REQUEST FOR COUNCIL ACTION

Originating Department Community Development	By GPD	Approved for Agenda by:	Date: Time:	Number:
Agenda Section DEVELOPMENT BUSINESS		Item Rezone from CB(PD) to CB, Preliminary Plat, Conditional Use Permit, and Final Site Plan and Building Plans

Case 10329ABC-97

- 1) Rezone property from CB(PD) Central Business (Planned Development) to CB Central Business (Case 10329A-97);
- 2) Preliminary Plat of Oxboro Heath 3rd Addition (Case 10329B-97); and
- 3) Conditional use permit and final site plan and building plans for a freestanding restaurant (Case 10329C-97).

POLE SIGN

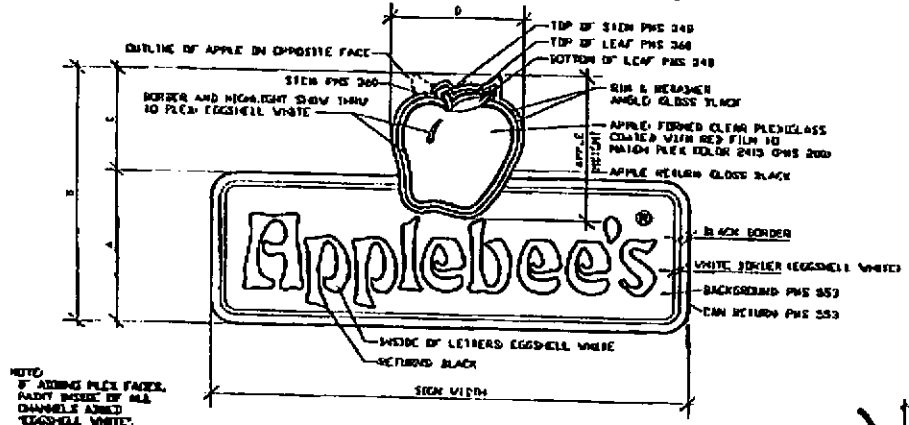
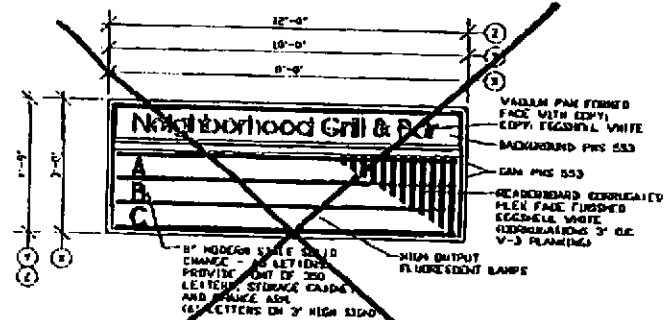
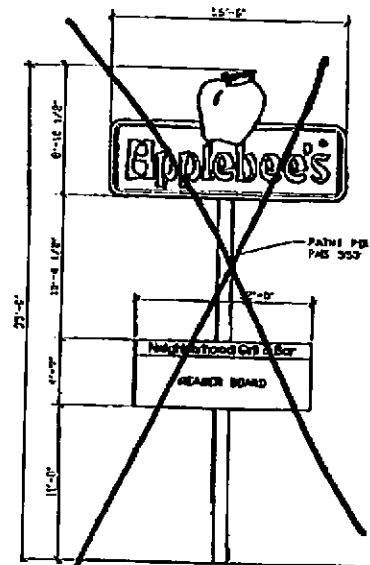
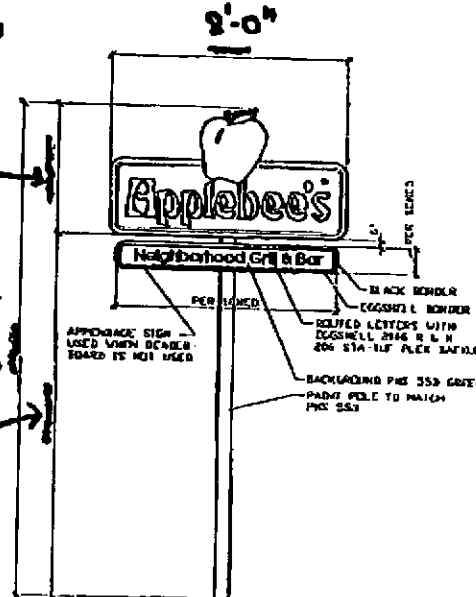
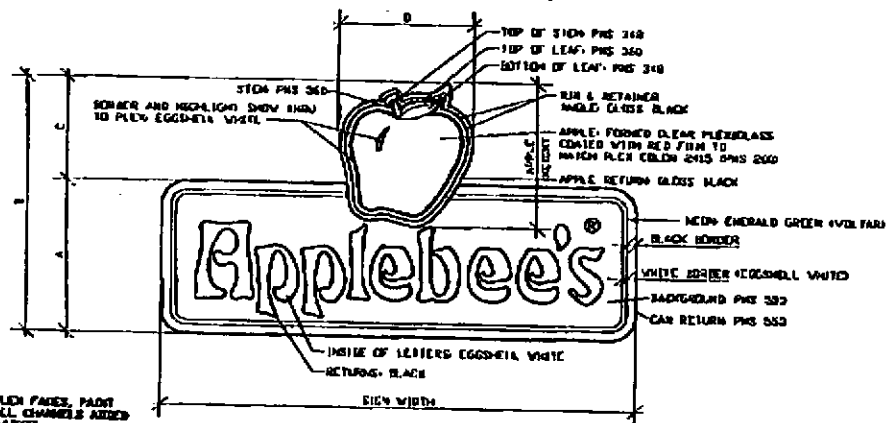
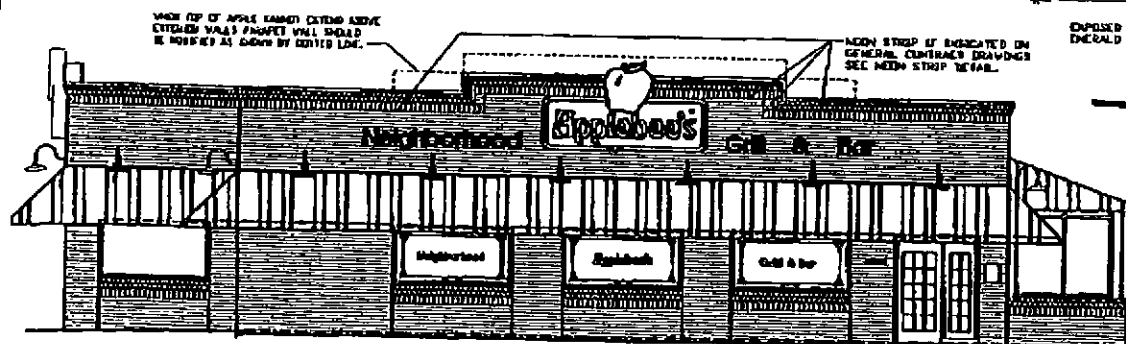
Additional information is required for both the lighting plan and the sign plan, which can be addressed prior to any permit issuance. It is noted that the drawing submitted (and attached to this report) indicate that both cabinet signs and channel letters are shown on the walls. This is not permitted by the sign code.

After

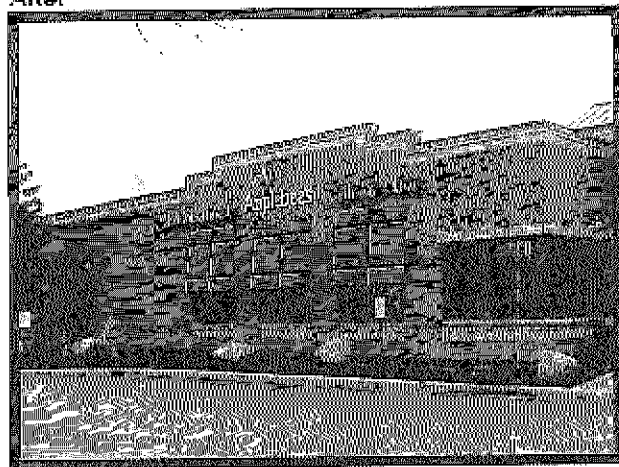
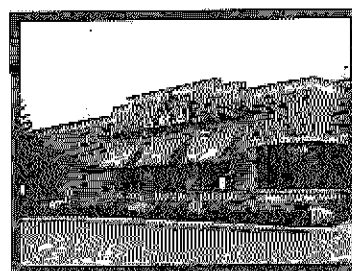
Sheet E13 does not have the square footage of the existing "Neighborhood Grill & Bar" sign. Could you please send me an updated sheet with that calculation.

Yes I will send it on Monday. They are the same size as the ones on the front elevation. Also the added specs for the lighting on the eyebrow which is
The fixture type is: HALO LIGHTING / PART# H27-RT FIXTURE
HALO LIGHTING / PART# 70P LENS
60W A19 MEDIUM BASE BULBS
